**Staff Report: Consent Site Plan Amendment 8200034A,
 Avalon Bay at Rock Spring Centre**

DESCRIPTION: Amendment to reduce the number of approved residential units by 4 to reflect as-built conditions, and to modify the existing cul-de-sac on Rock Forest Drive; 10.47 acres; MXPDP Zone; located on the Northeast quadrant of the intersection of Rockledge Drive and Rock Forest Drive; 1992 North Bethesda Garrett Park Master Plan.

SUMMARY: Amendment to reduce the number of approved multi-family residential units from 390 to 386 to reflect as-built conditions, and to modify the existing cul-de-sac on Rock Forest Drive in order to provide connectivity to the proposed street network on site plan No. 820090030 (Rock Spring Centre – Phase III).

Illustrative Plan with cul-de-sac area highlighted in red

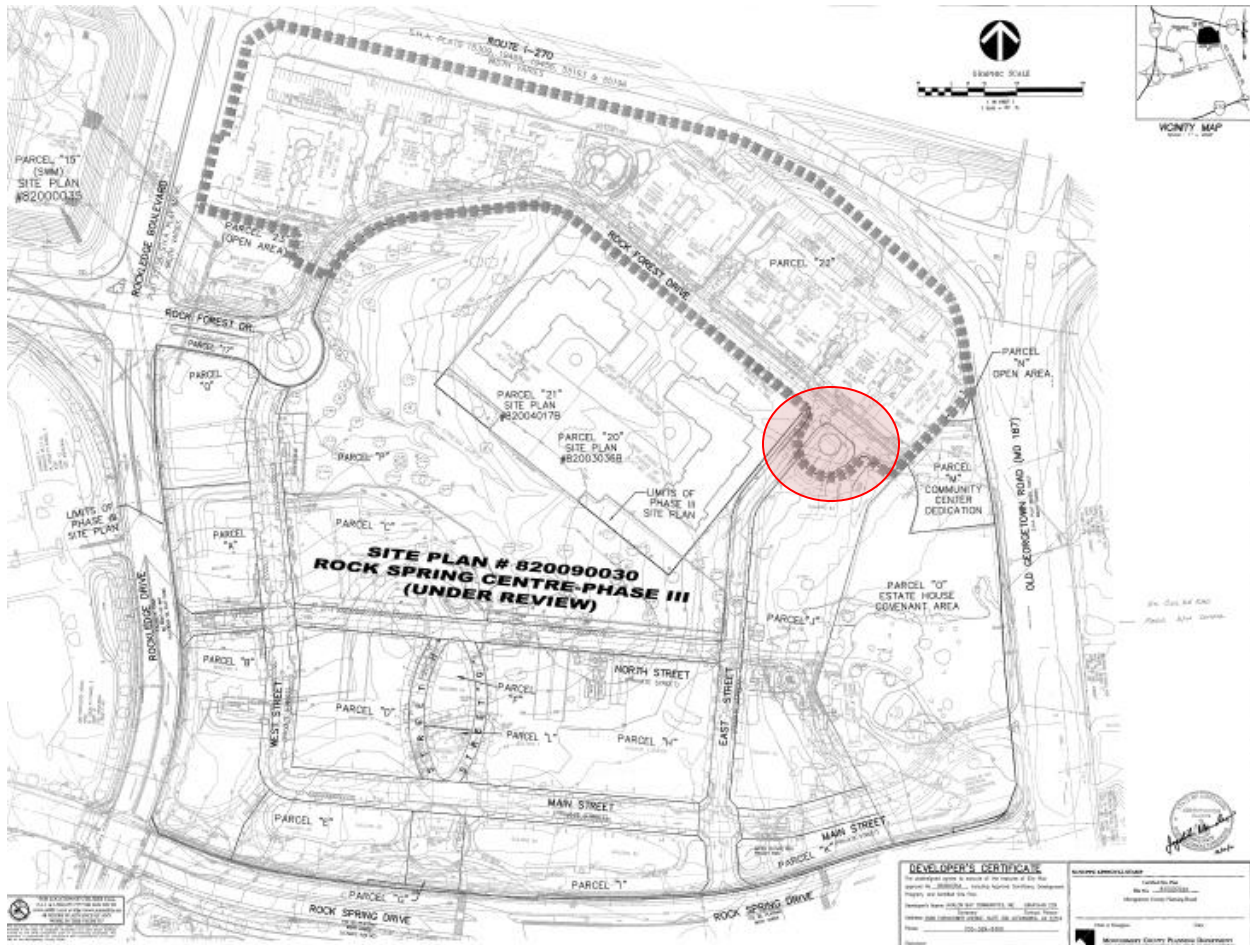
The Amendment proposes to modify the existing cul-de-sac on Rock Forest Drive in order to provide connectivity to the proposed street network on site plan No. 820090030 (Rock Spring Centre – Phase III). Existing Rock Forest Drive, which provides access to the residential buildings at Avalon Bay and future Towers I and II, will be connected to the proposed East Street and jointly form an internal loop road. The excess pavement from the existing cul-de-sac will be removed.
